ADDENDUM NUMBER 4

Issued: December 7, 2012

**North Bay Water Reuse Program
Sonoma Valley County Sanitation District
Napa Salt Marsh Restoration Pipeline
(Carneros Reservoir to Huichica Unit)**

FILE NAME: 7490_C-002.dwg
CONTRACT NUMBER: 7490
DRAWING NUMBER: C-002
SHEET 7 OF 40

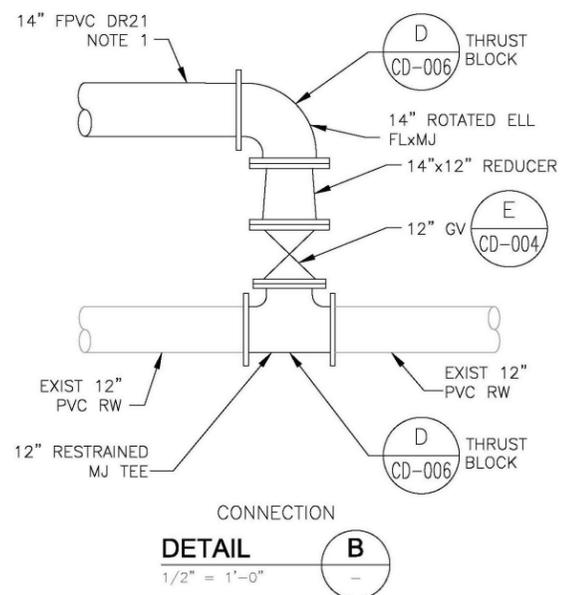
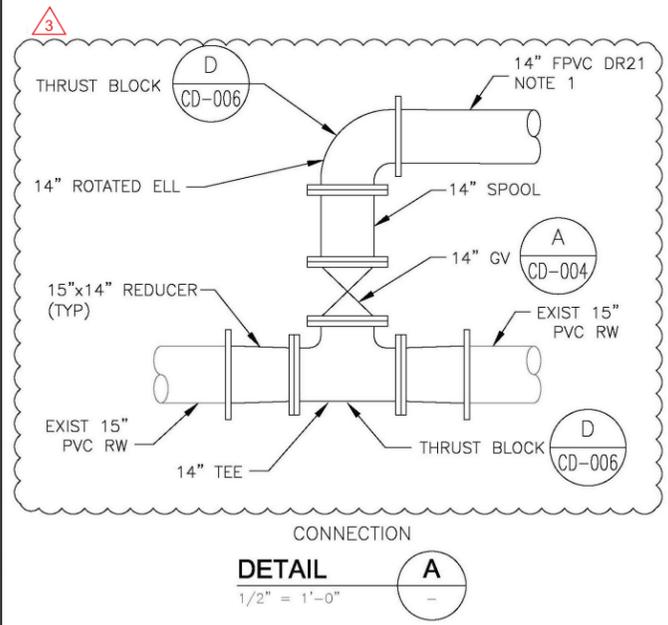
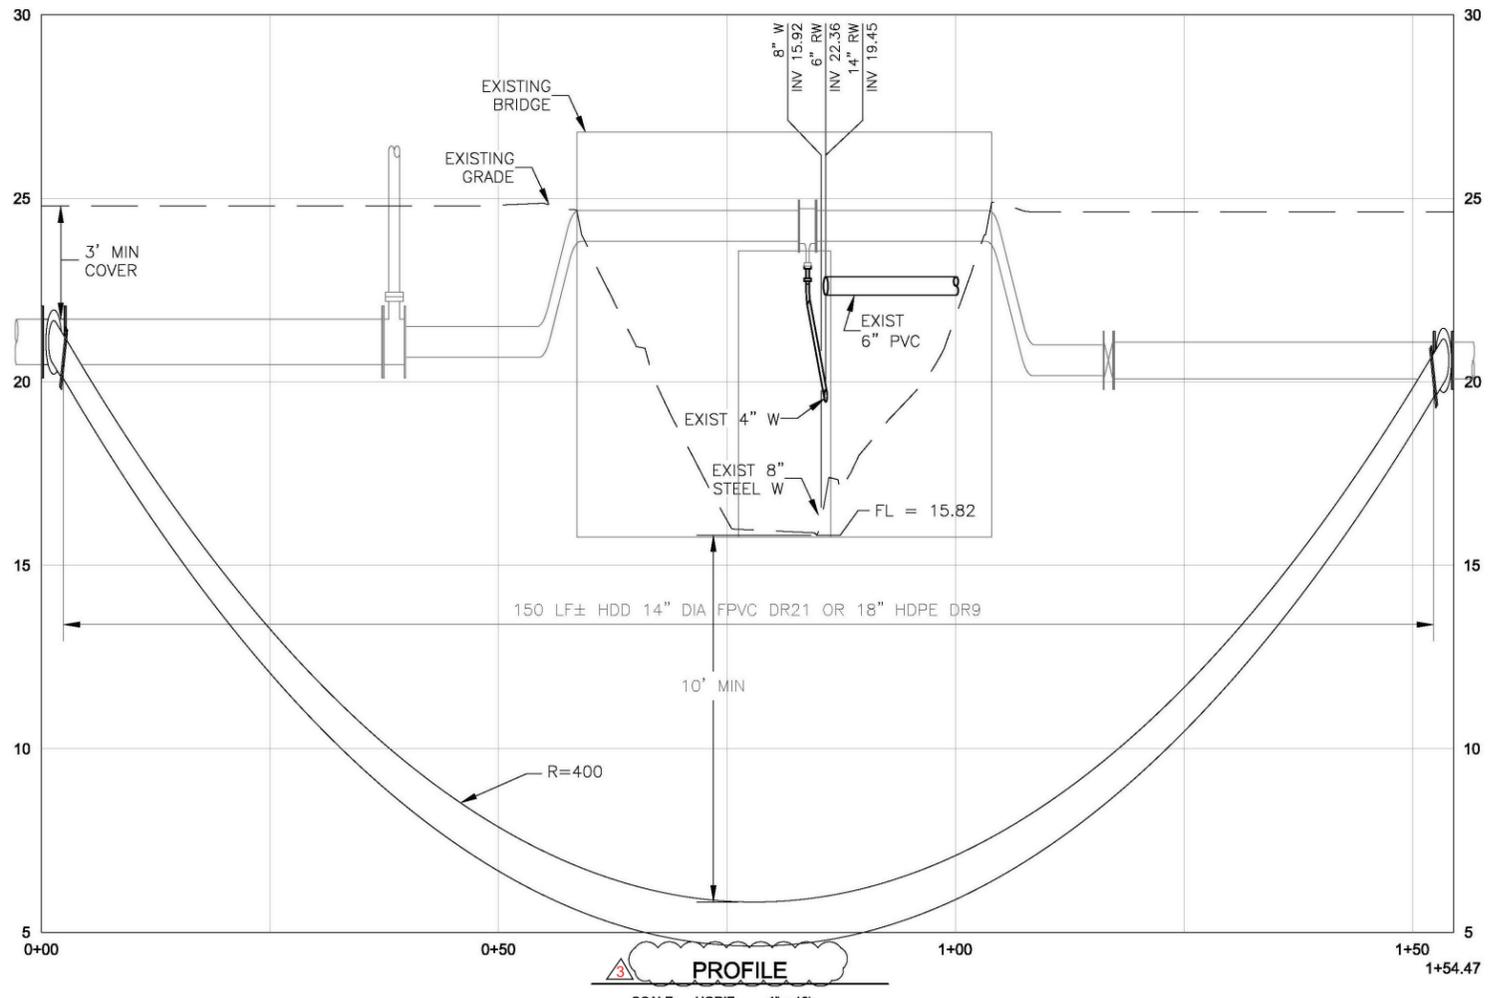
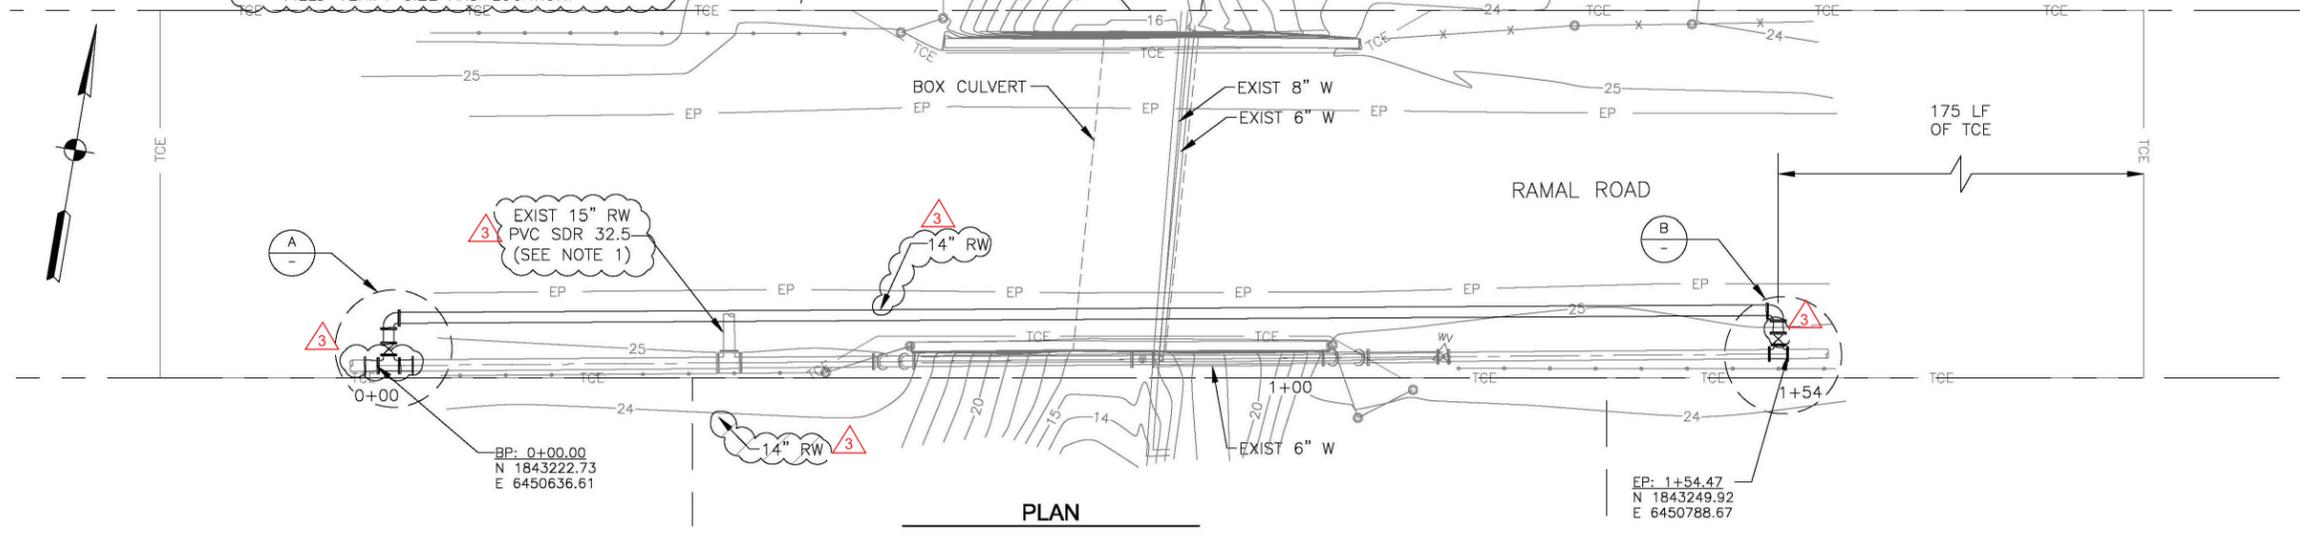
- 2. What type of 15" pipe was used on page c-002 sheet 7 of 40 at the Ramal Road Bridge? C9005 is not made in 15" DIA.

- 4. 15" x 15" MJ Tees are not made, is this a printing error?

1. IF HDPE IS UTILIZED, THE NOMINAL DIAMETER SHALL BE 18", DR9.

2. PROVIDE ATS FOR TEE, VALVE, REDUCER & ELBOW, SEE DETAIL A/CD-007

- A. Delete Drawing No. C-002 and replace with Drawing No. C-002 attached and marked "12/7/12 Addendum 4."

NAPA SALT MARSH RESTORATION PIPELINE
ENVIRONMENTAL PROTECTION DETAILS (1 OF 2)

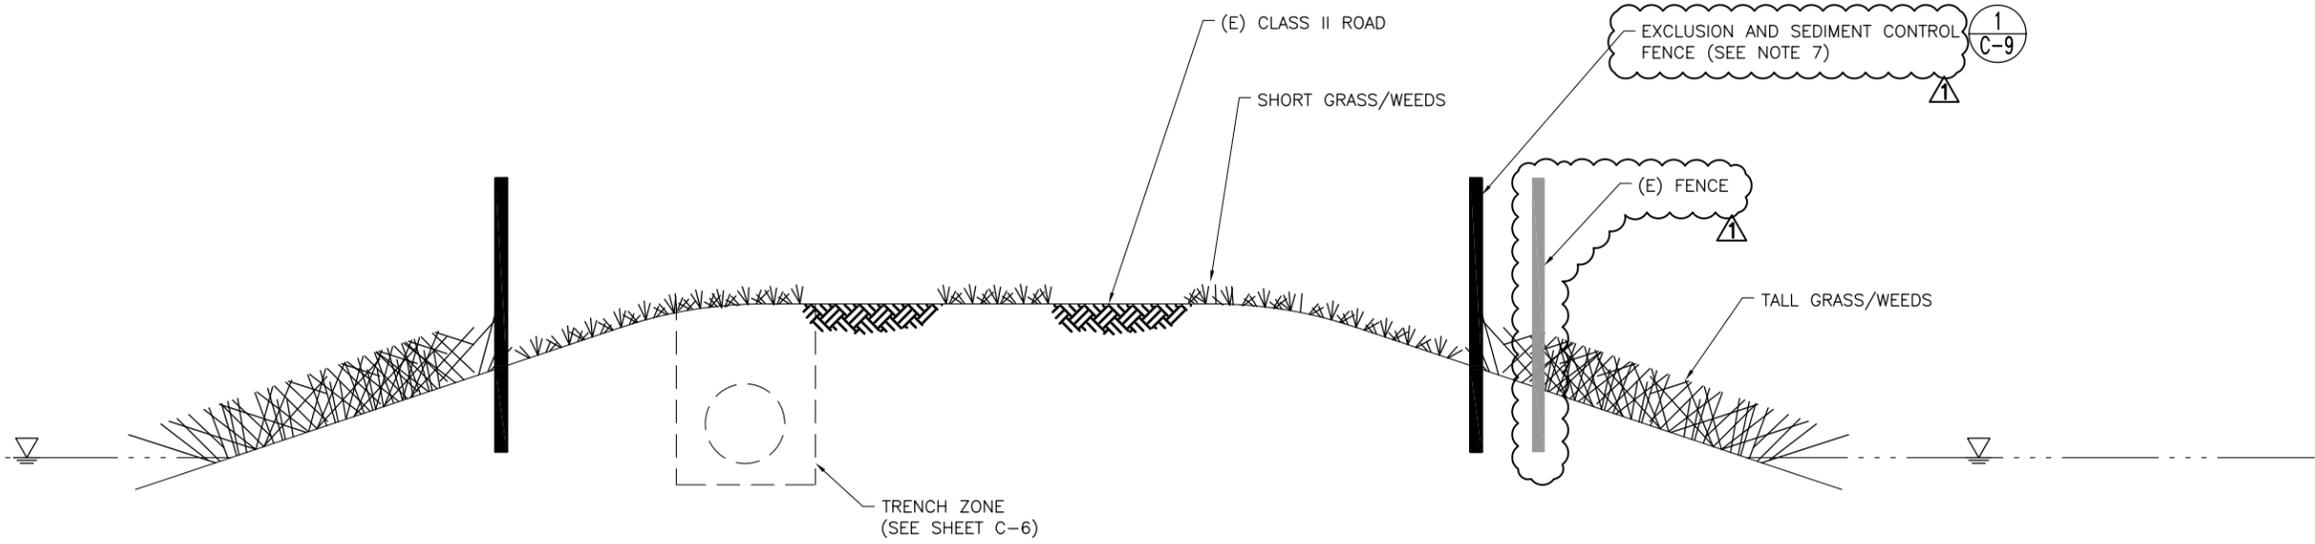
1. INSTALL SILT FENCE AT EDGE OF TALL GRASS/WEEDS.
2. RESTORE DISTURBED AREAS WITH NATIVE CALIFORNIA GRASS SEED MIXTURE.
3. RESTORE GRAVEL/GRASS RIBBON ROAD.
- ~~4. COORDINATE SILT FENCE INSTALLATION WITH OWNER.~~
5. COORDINATE FENCE INSTALLATION WITH OWNER.
- ~~6. STAKES SHALL BE 5' METAL "T" POLES SPACED NO FURTHER THAN 4' ON CENTER.~~
7. INSTALL EXCLUSION FENCING AND SEDIMENT CONTROL TO SURROUND AND ISOLATE OPEN TRENCH AND AREAS OF ACTIVE CONSTRUCTION IN SEGMENT 2

- C. Delete Drawing No. C-8 and replace with Drawing No. C-8 attached and marked "12/7/12 Addendum 4."
- D. Delete Drawing No. C-9 and replace with Drawing No. C-9 attached and marked "12/7/12 Addendum 4."
- E. Drawing CP-1:
 - 1. Add Note 5 as follows:
 - 5. Cathodic protection is required for all valves. Place test stations adjacent to valve operator.

DETAIL - EXCLUSION AND SEDIMENT CONTROL FENCE 1
SCALE: NTS C-8

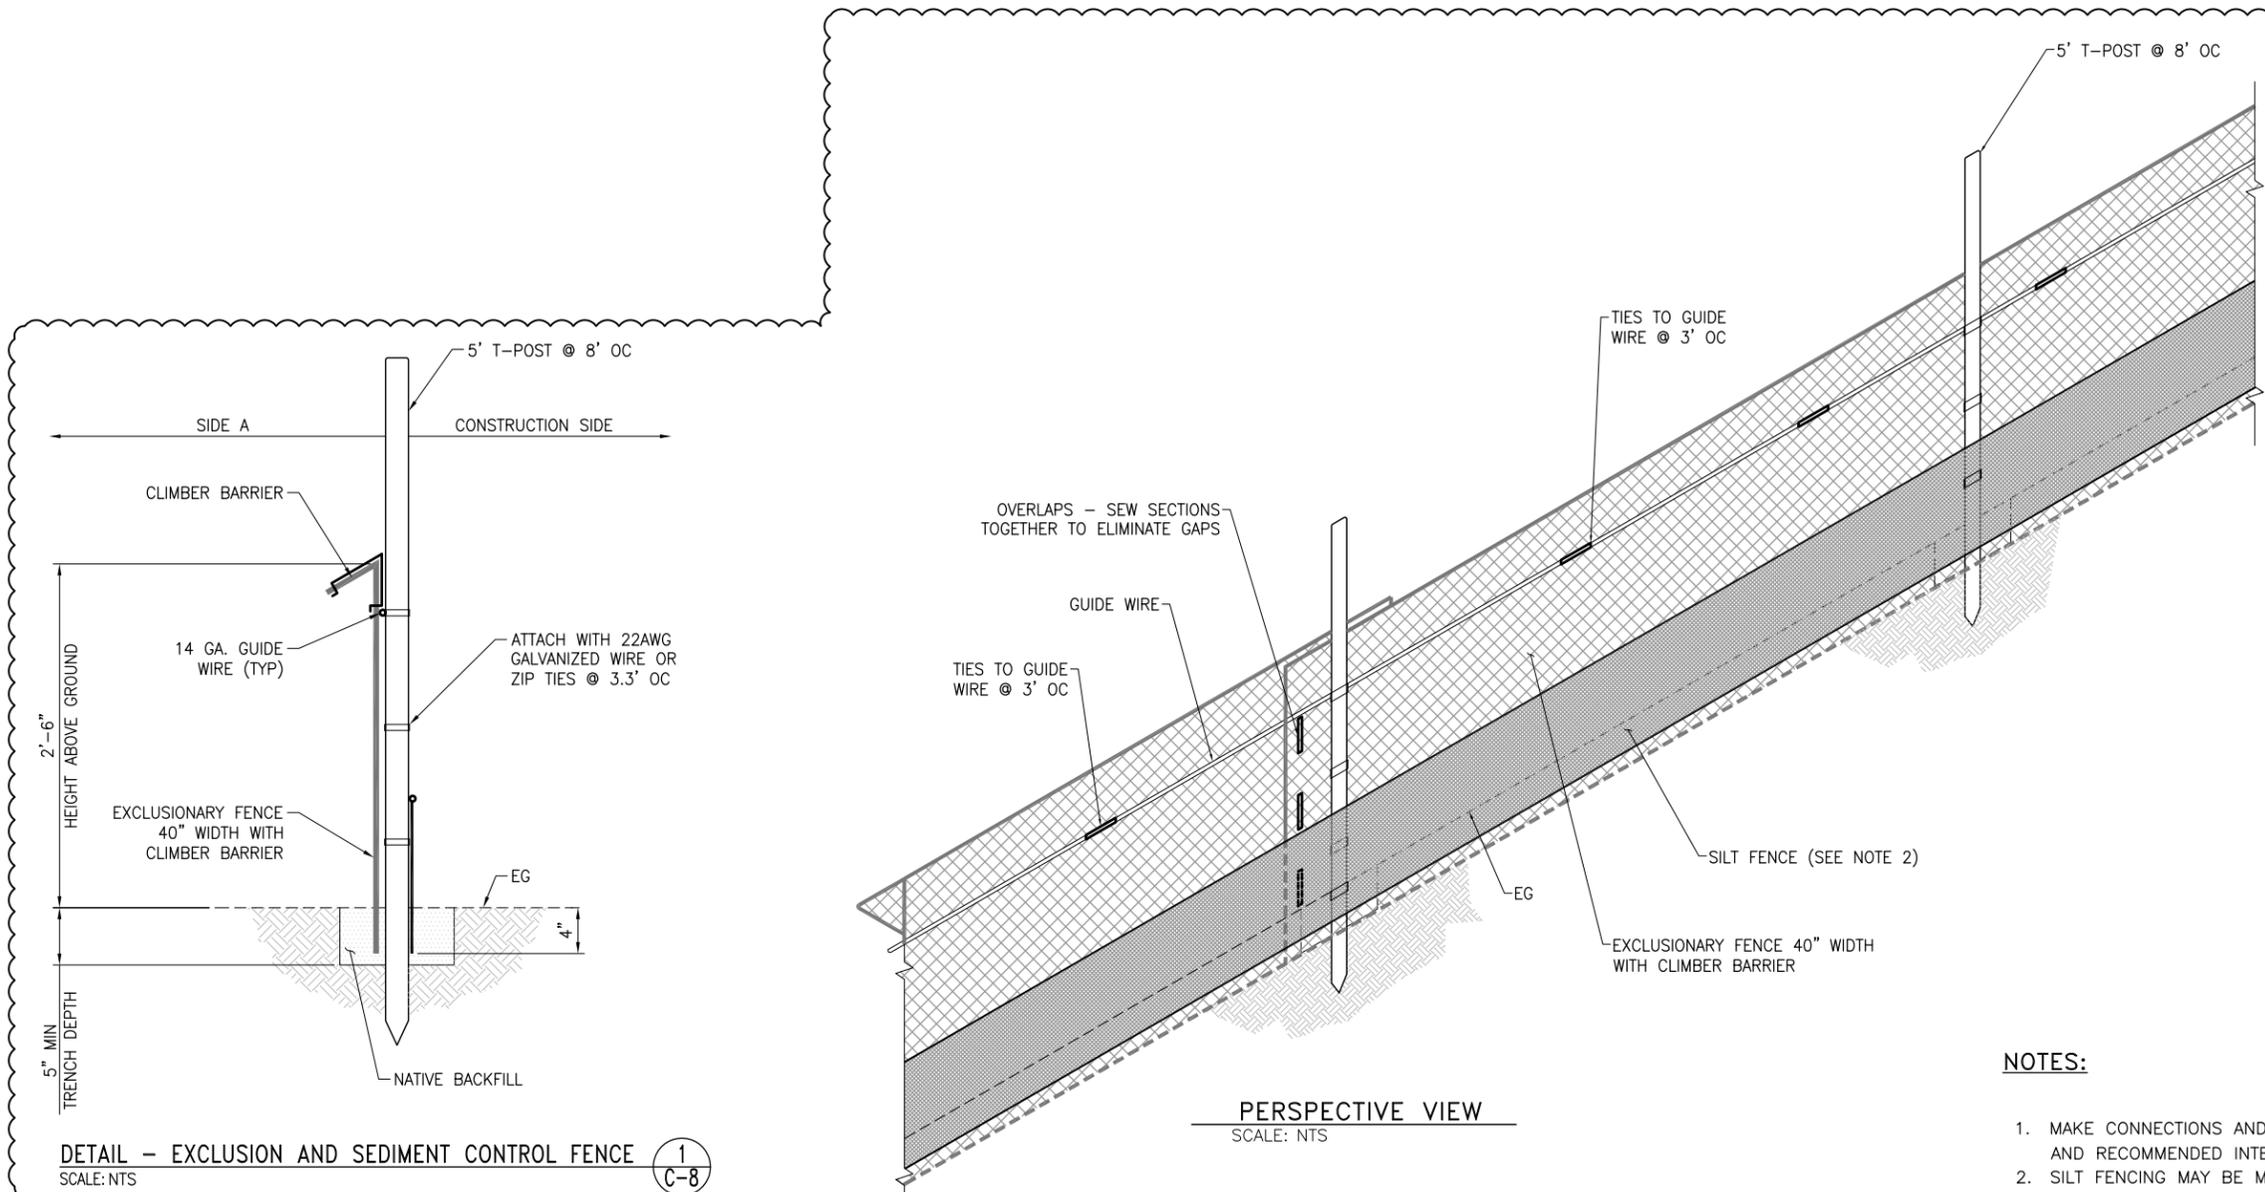
1. MAKE CONNECTIONS AND ATTACHMENTS ACCORDING TO MANUFACTURER'S INSTRUCTIONS AND RECOMMENDED INTERVALS.
2. SILT FENCING MAY BE MOUNTED TO INBOARD SIDE OF EXCLUSION FENCING, PROVIDED IT DOES NOT INTERFERE WITH EXCLUSION FENCING FUNCTION. IF SEDIMENT CONTROL BE ATTACHED TO THE SILT FENCE, THE ATTACHED MATERIAL SHALL BE A WOVEN MONOFILAMENT GEOTEXTILE OR OTHER PERMEABLE SILT FENCE INSTALLED IN ACCORDANCE WITH THE EXCLUSION FENCING MANUFACTURER'S RECOMMENDATION . SUBMIT WITH SWPP.
